# SERVICE BULLETIN

# No. SB-300-1-11

# Safety clamps on Garmin avionics units located in subpanels

Aircraft affected: EA 300 including models EA 300/S, EA 300/L, EA 300/200, EA 300/SC, EA 300/LT and EA 300/LC aircraft manufactured before July 2011 and equipped with optional Garmin avionics units (GNC 250XL, GTX 320, GTX 320, GTX 327, GTX 328, GTX 330, GNC 420[W], GNS 430[W], GNS 530[W]) within the instrument subpanel.

Figure 1: Slide out of units when not securely locked

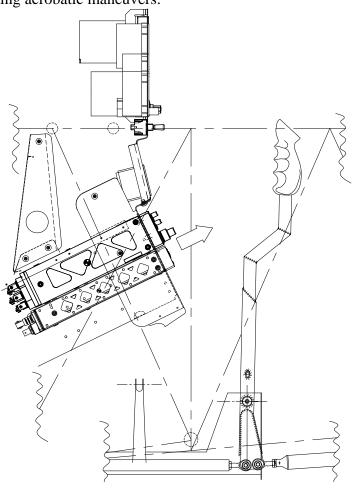
**Purpose:** It has been reported that a Garmin transponder GTX 328 slid out of its rack in a EA 300/L and jammed against the control stick while performing acrobatic maneuvers.

Initial investigation showed that the front lobe of the locking mechanism was not in the full  $90^{\circ}$  vertical position to securely lock the unit in its rack. All above mentioned Garmin units feature the same locking mechanism.

Safety clamps are introduced to prevent the units to slide out when the Garmin locking mechanism fails or is improperly used.

Figure 3: Typ. arrangements of Garmin avionics units within the EA 300/L instrument subpanel

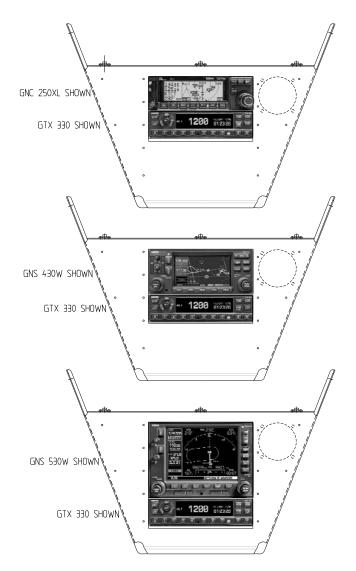
Part II addresses the retrofit of two (2) safety clamps to the Garmin units installed in the instrument subpanel as an additional safety means to the locking device of the affected Garmin units. There are many different configurations/arrangements of Garmin avionics units within the instrument subpanel in the field. See figure 3 for typical installations.

- Remove the Garmin units from their racks. Insert a 3/32-inch hex drive tool into the access hole on the unit face and rotate counter-clockwise until the mounting screw turns freely and the unit protrudes about 3/8 inch from the panel.

Figure 4: Attachment screws of the the instrument subpanel (EA 300/L shown)

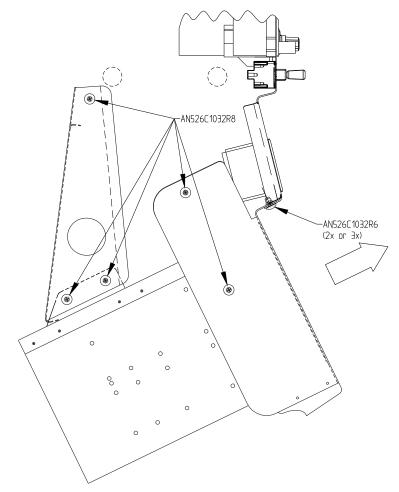
- Disconnect wirings of electrical units located in the instrument subpanel (as required)
- Unscrew AN526 series attachment screws from the instrument subpanel and remove the subpanel in rearward direction to the pilots seat while the control stick is in the most LH or RH control input position (see figure 4). In some cases the LH and RH AN526 fuselage attachment screws of the instrument panel have to be unscrewed as well.

Figure 5: Attachment screws of the the instrument subpanel (EA 300/S shown)

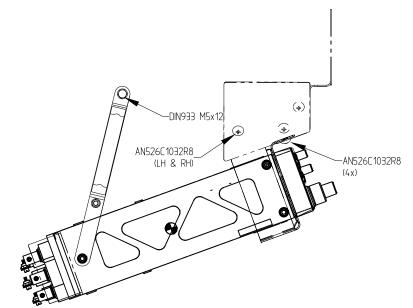
- b) For single seater variants/models:
- Remove canopy per Chapter 53-00-10
- Remove the engine cowling and main fuselage cover 51-00-01 (as appropriate)
- Disconnect wirings of electrical units located in the instrument subpanel (as required)
- Unscrew AN526 and DIN 933 attachment screws of the instrument subpanel and remove the subpanel in rearward direction to the pilots seat while the control stick is in the most LH or RH control input position (see figure 5). In some cases the

instrument panel also includes the subpanel (one part). This may require the removal of the instrument panel.

*Figure 7: Alternative position of safety clamps (EA 300/L shown)*

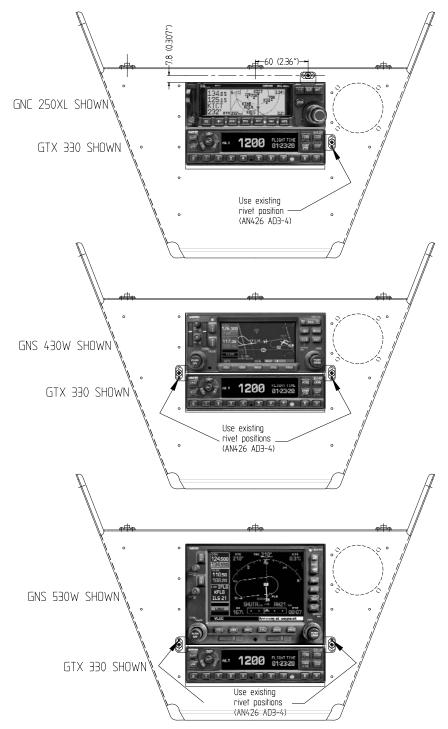
If the configuration prevents this a RH and LH position or a combination is appropriate. Positions for the LH and RH are established by existing rivets (refer to Figure 7). Other positions may also be appropriate. The solid aluminum countersunk rivet positions can be easily recognized from the rear.

- For LH and RH positioned safety clamps: Remove the two (2) identified solid aluminum countersunk rivets.
- Drill needed holes for the nutplates used to attach the two (2) safety clamps at the appropriate locations.

Figure 8: Typical installation of safety clamps (top/bottom)

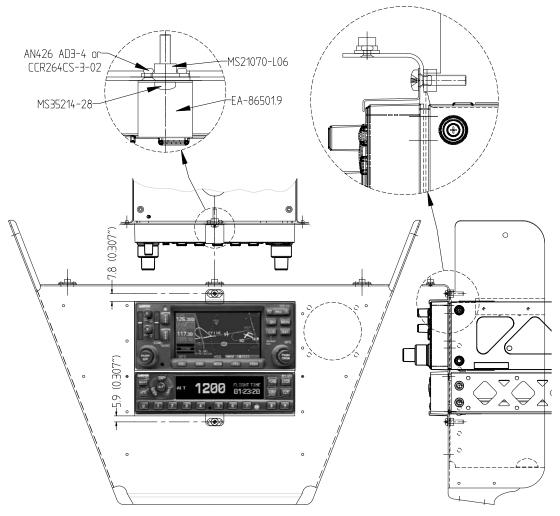
- Install the nutplates using solid aluminum countersunk or nut plate flush head rivets (refer to figure 8. and 9.).

Figure 10: Suitable safety clamp made of stainless steel sheet, 0.5mm [0.015"] thick

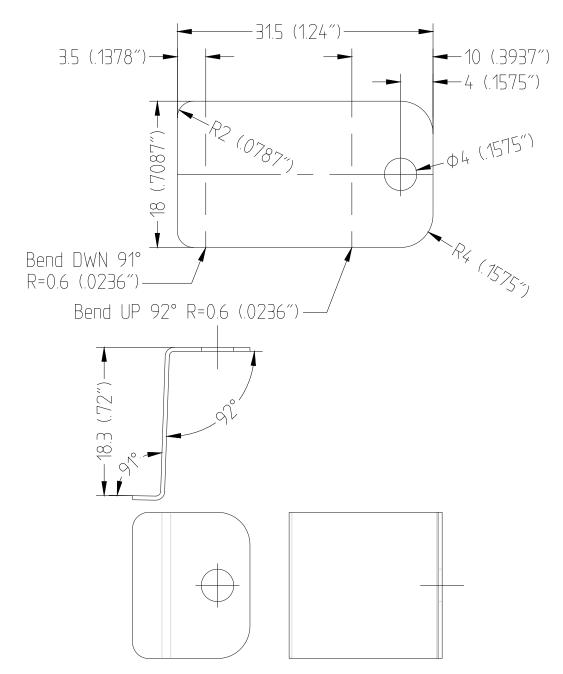
Safety clamps (2x)
